March 31, 2004

Re: Response to NRC's Requests for Additional Information (RAIs) #5 on Class 1 Pressure Boundary Design and Materials Review of Fuel Channels and On-Power Fueling

(Letter V. Langman to B. Sosa, "Response to NRC's Requests for Additional Information (RAIs) #5 on Class 1 Pressure Boundary Design and Materials Review of Fuel Channels and On-Power Fueling", March 31, 2004)

Figure 91-1: Flow sheet showing the limits of the Class 1 Reactor Coolant Pressure Boundary

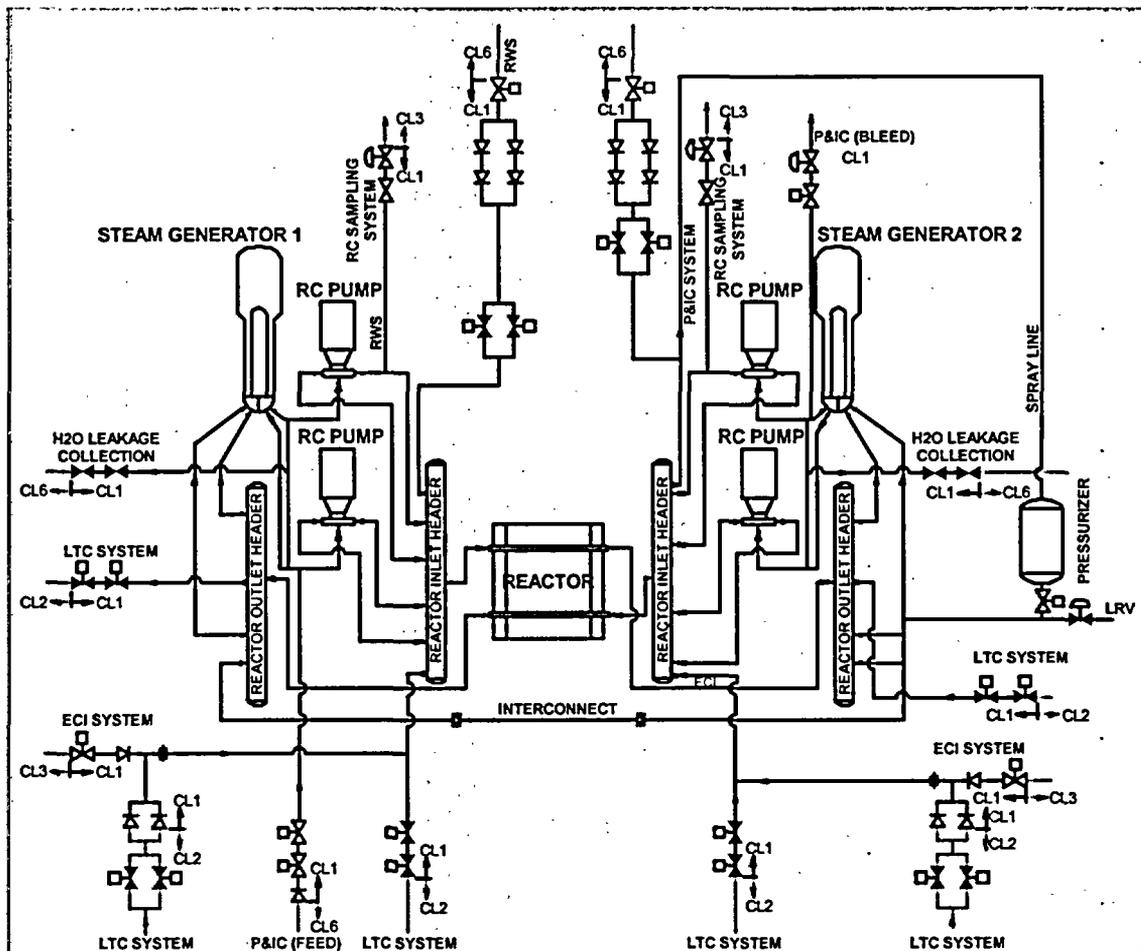
91. AECL requested a staff acceptance of certain aspects of the ACR-700 pressure boundary design. AECL should define the extent of the reactor coolant pressure boundary and discuss its compliance with the definition of the reactor coolant pressure boundary provided in 10 CFR 50.2. AECL should provide this information for the case where the fueling machine is attached and the case where the fueling machine is not attached. AECL should identify any pressure boundary components that meet the definition of the reactor coolant pressure boundary provided in 10 CFR 50.2 and are not designated Class 1. AECL should provide the basis for the classification of the components not designated Class 1.

The extent of the reactor coolant pressure boundary (RCPB) can be defined with reference to the attached Figures 91-1 and 91-2. The flow sheet in Figure 91-1 shows all components that make up the pressure boundary when the fueling machine is not attached. Due to differences in Canadian and US regulations regarding Code Classifications, some of the code classifications for adjoining systems are under review. As a result some of the valve classifications shown in the figure for the second valve forming the limit of the boundary according to US regulations may change. The Figure should be used for defining the limits of the Class 1 boundary.

All the components within this boundary are designed to the rules of ASME Section III Division 1. With the exception of fuel channel components, all the materials used to form the pressure boundary are ASME accepted materials for Class 1 application and are used within their limits of applicability.
